SUBJECT: FORT CALHOUN STATION, UNIT 1 - STAFF ASSESSMENT OF INFORMATION PROVIDED PURSUANT TO TITLE 10 OF THE *CODE OF FEDERAL REGULATIONS* PART 50, SECTION 50.54(f), SEISMIC HAZARD REEVALUATIONS FOR RECOMMENDATION 2.1 OF THE NEAR-TERM TASK FORCE REVIEW OF INSIGHTS FROM THE FUKUSHIMA DAI-ICHI ACCIDENT (TAC NOS. MF3735)

STAFF ASSESSMENT BY THE OFFICE OF NUCLEAR REACTOR REGULATION

RELATED TO SEISMIC HAZARD AND SCREENING REPORT

FORT CALHOUN STATION

Figure 3.3- 1 Plot of Staff's and Licensee's Base Case Shear-Wave Velocity Profiles for the FCS site

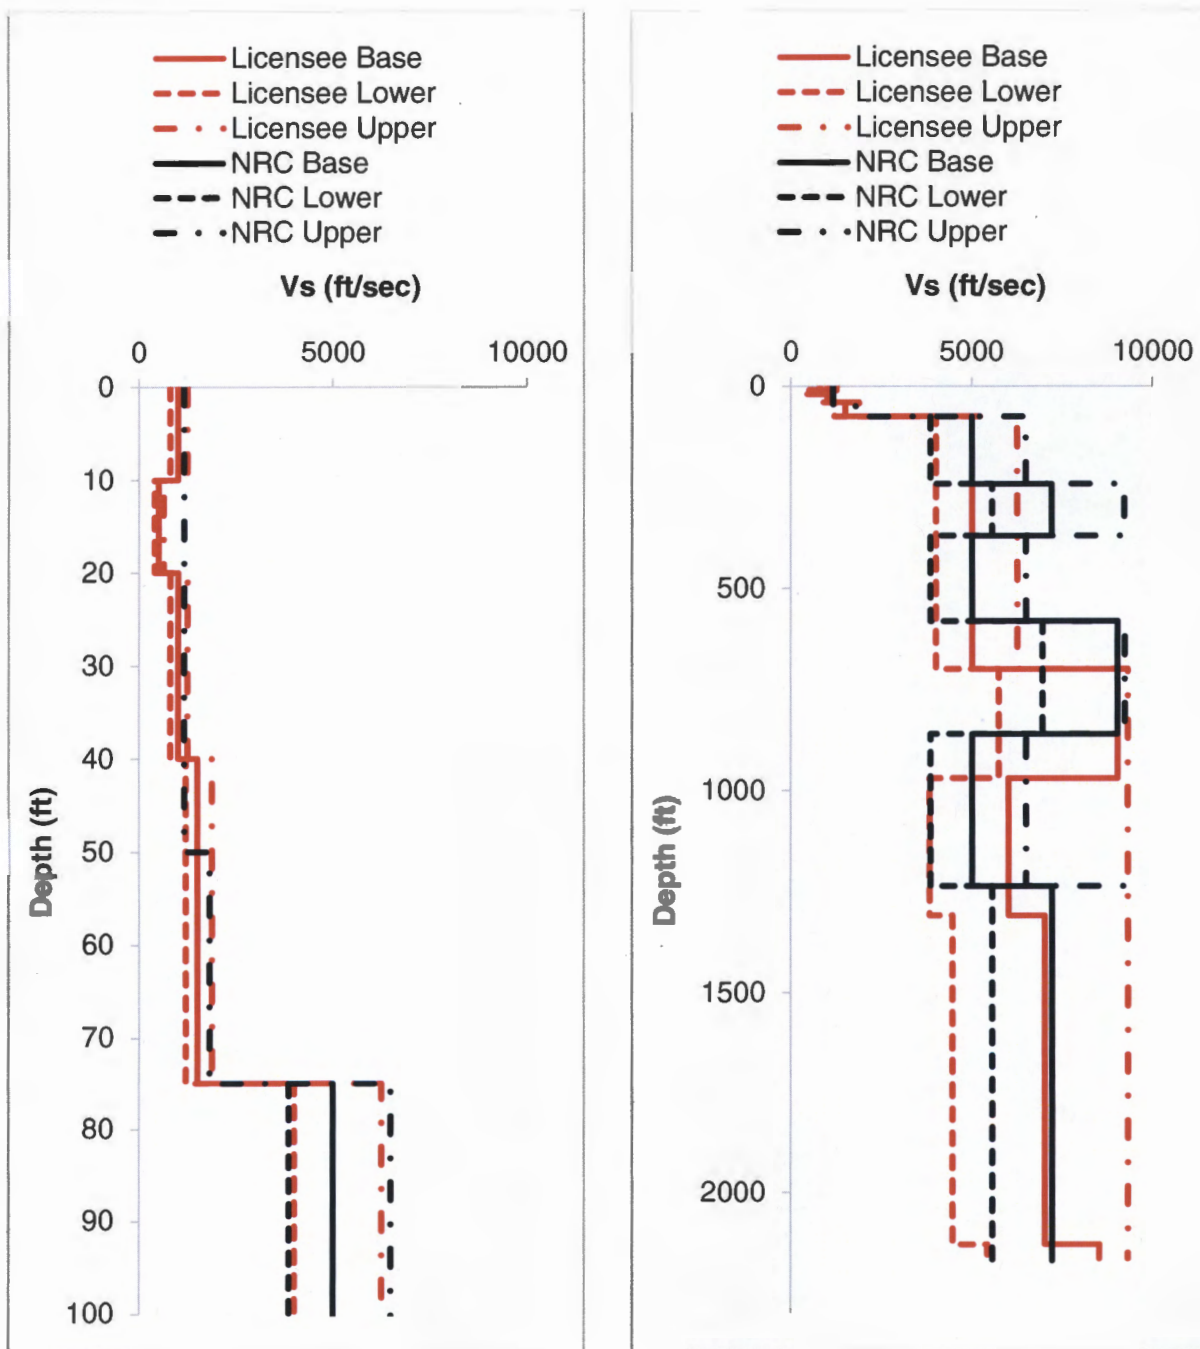
To characterize the subsurface geology, the licensee developed three site base case profiles. The licensee's middle, or best estimate, profile was developed using measured shear-wave velocities to a depth of 700 ft (213 m). Below this depth, the licensee used data from nearby water, oil and gas wells to develop the shear wave velocities. Consistent with the SPID, the licensee developed the upper and lower base case profiles using a scale factor of 1.25 in the upper 700 ft (213 m) and 1.57 below that depth. Figure 3.3-1 of this assessment shows the licensee's three shear-wave velocity base case profiles.

Following guidance provided in the SPID for sites with little at-site information, the NRC staff independently determined best-estimate, upper and lower base case profiles for the FCS site. To develop upper and lower base case profiles, the NRC staff used a scale factor of 1.57. The staff's base case shear-wave velocity profiles are shown along with the licensee's base case profiles in Figure 3.3-1 of this assessment. The staff's shear wave velocity profiles are similar to those submitted by the licensee with only a minor difference in the estimated depth to individual

sedimentary rock formations and the staff's interpretation of a shear wave velocity estimate of 7200 fps (2195 m/s) for a 130 ft (40 m) thick layer at a depth of 170 ft (52 m). The staff's estimate of 7200 fps (2195 m/s) is based on shear wave velocity estimates of similar rock formations.

**Figure 3.3- 2 Plot Comparing the Staff's and the License's Median Amplification Functions and Uncertainties for two input loading levels for the FCS site**

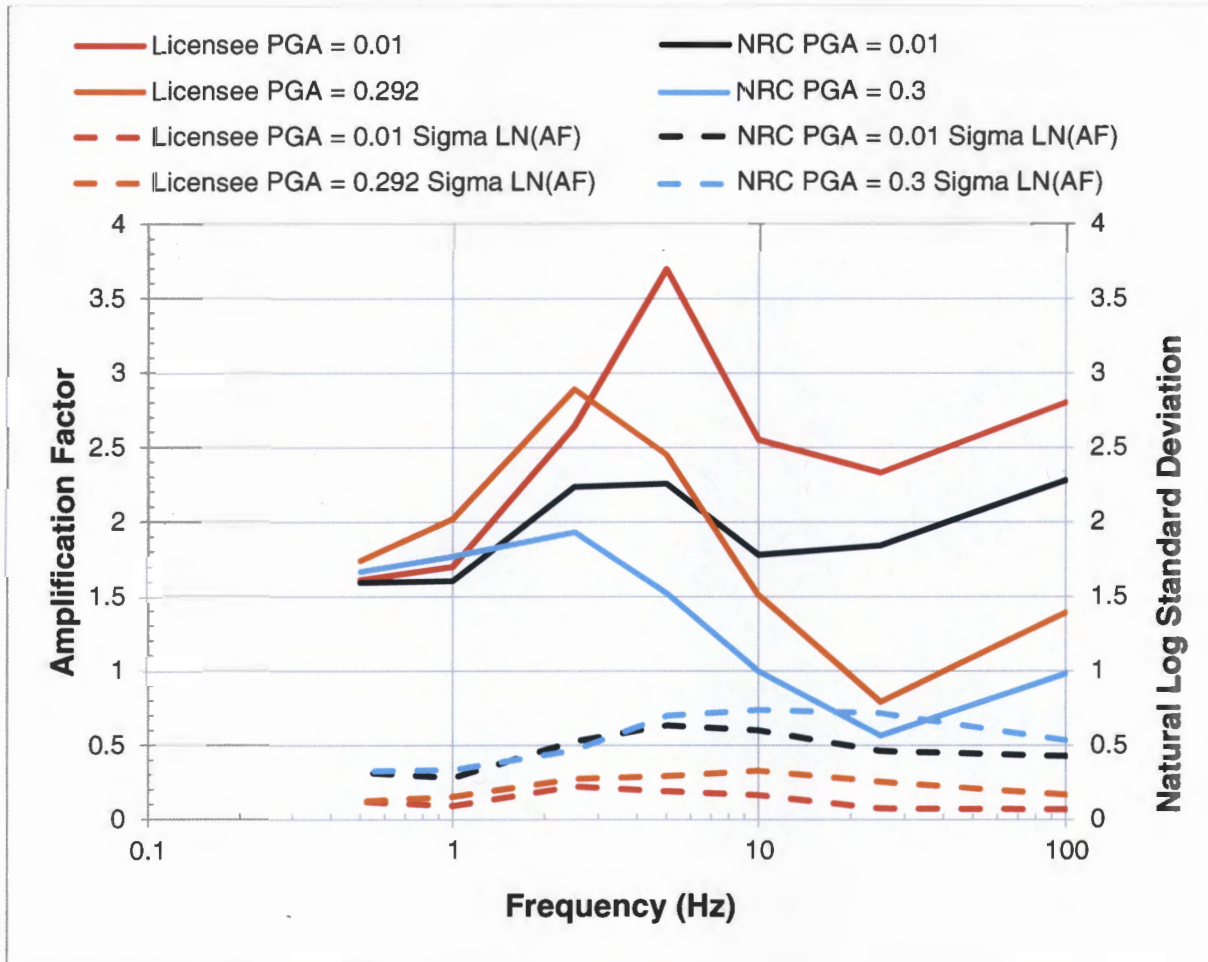
Figure 3.3-2 of this assessment shows a comparison of the staff's and the licensee's median site amplification functions and associated uncertainties ( $\pm 1$  standard deviation) for two of the eleven input loading levels. Both the staff's and licensee's site amplifications are similar in shape; however, the licensee has a higher peak amplification at 5 Hz compared with the staff's result. The licensee's larger peak amplification is due to differences in the staff's and licensee's velocity profiles as well as differences in the range of kappa values used by the NRC staff and licensee for the site response analyses.

Figure 3.3-3 Plot Comparing the Staff's and the Licensee's Mean Control Point Hazard Curves at a Variety of Frequencies for the FCS site

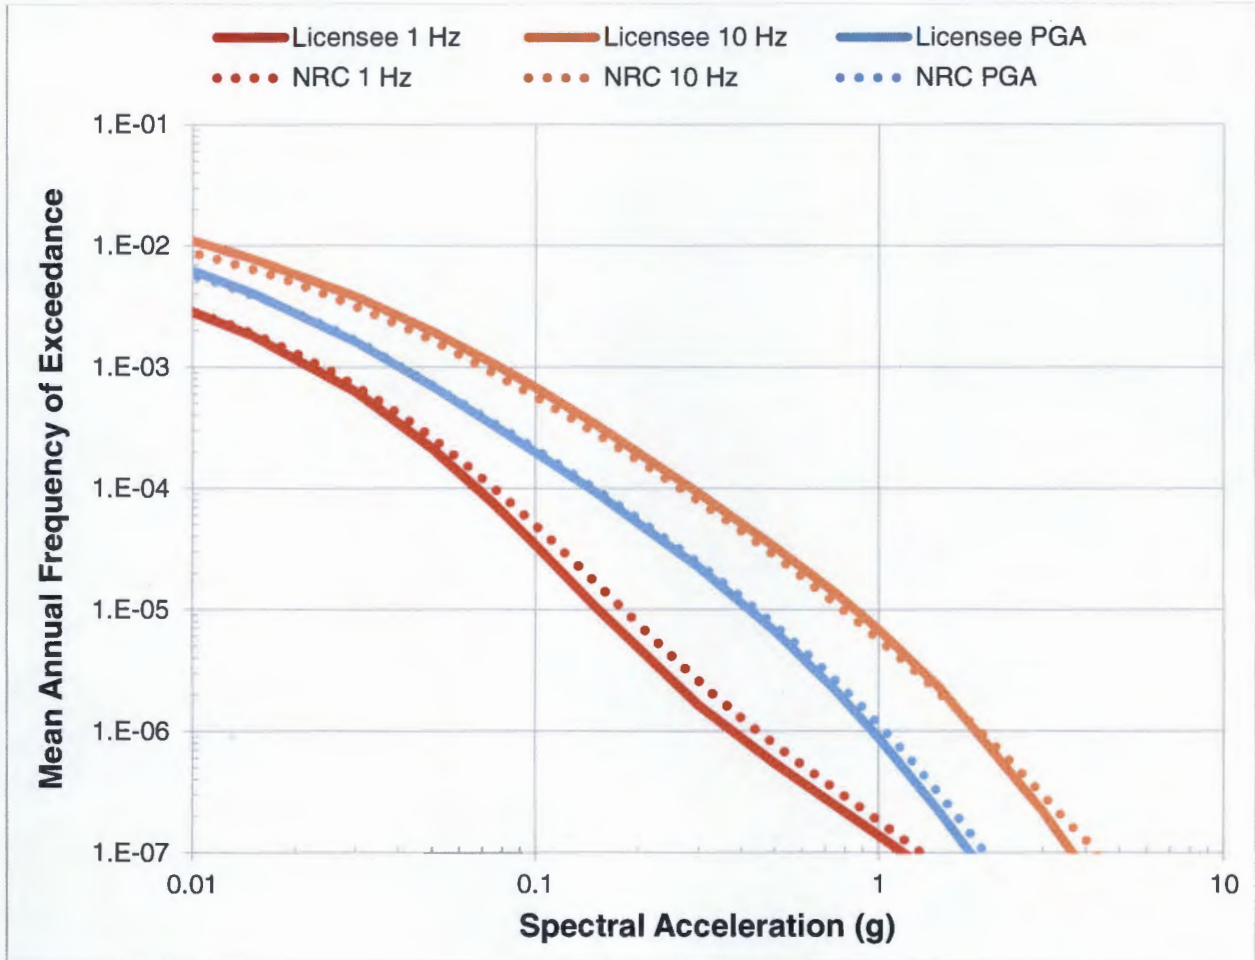
As shown in Figure 3.3-3 of this assessment, differences in site response analyses have only a minor impact on the control point seismic hazard curves and the resulting GMRS, discussed below. Overall, the control point seismic hazard curves developed by the NRC staff are similar to those developed by the licensee. Appendix B of the SPID provides guidance for performing site response analyses, including capturing the uncertainty for sites with less subsurface data; however, the guidance is neither entirely prescriptive nor comprehensive. As such, various approaches in performing site response analyses, including the modeling of uncertainty, are acceptable for the 50.54(f) response.

Figure 3.4-1 Comparison of the Staff's GMRS with Licensee's GMRS and the SSE for the FCS site

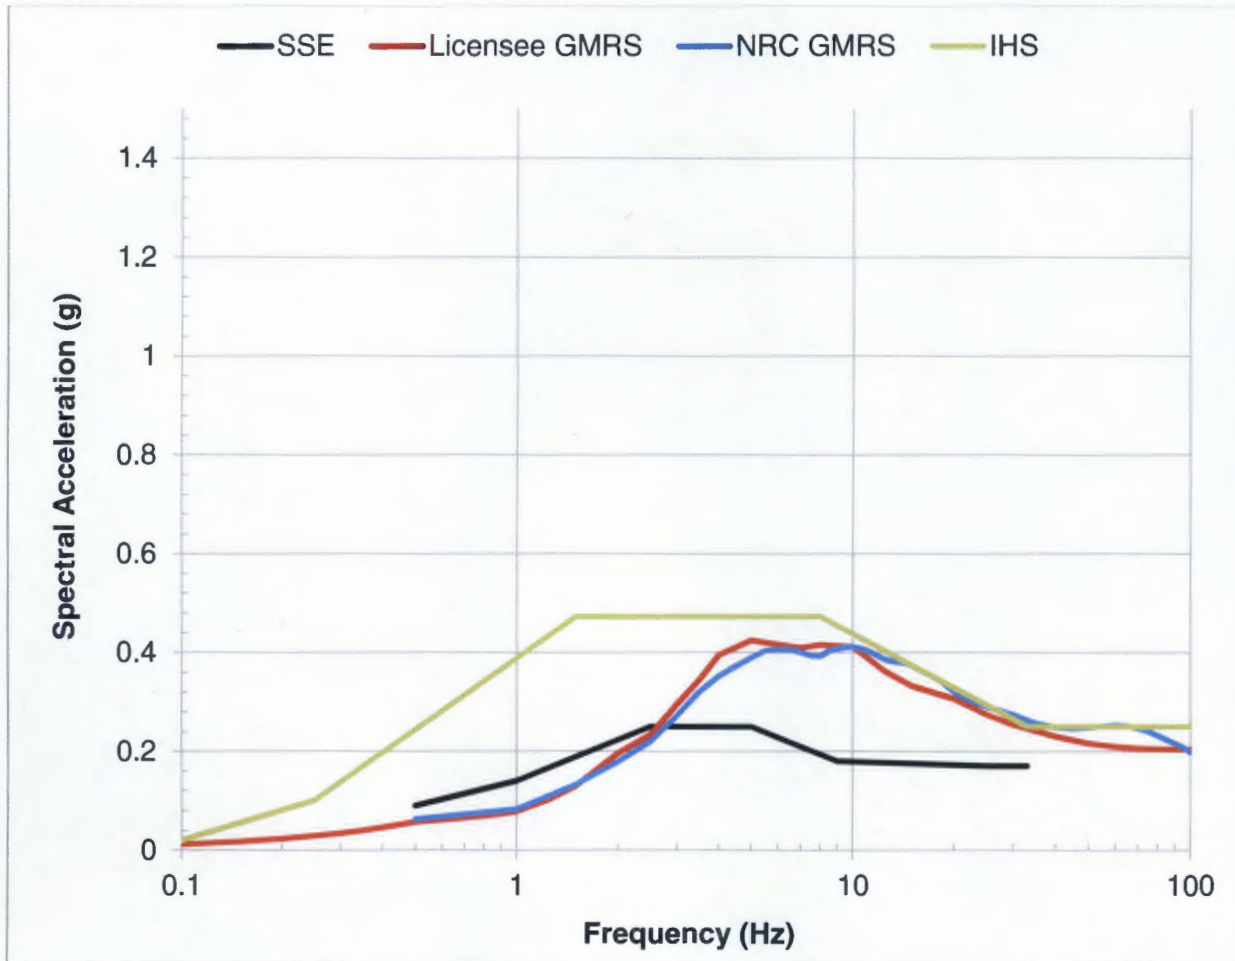
The NRC staff independently calculated the  $10^{-4}$  and  $10^{-5}$  UHRS using the results of its confirmatory PSHA and site response analysis, as described in Sections 3.2 and 3.3 of this NRC staff assessment, respectively. Figure 3.4-1 of this assessment shows a comparison of the GMRS determined by the licensee to that determined by the NRC staff.

As shown in Figure 3.4-1 below, the licensee's and staff's GMRS are very similar. As described above in Section 3.3, the NRC staff concludes that these minor differences are primarily due to the differences in the site response analyses performed by the licensee and NRC staff. The NRC staff performed both a PSHA and site response confirmatory analysis and achieved results consistent with the licensee's horizontal GMRS. As such, the staff concludes that the GMRS determined by the licensee adequately characterizes the reevaluated hazard for the FCS site. Therefore, this GMRS is suitable for use in subsequent evaluations and confirmations, as needed, for the response to the 50.54(f) letter.
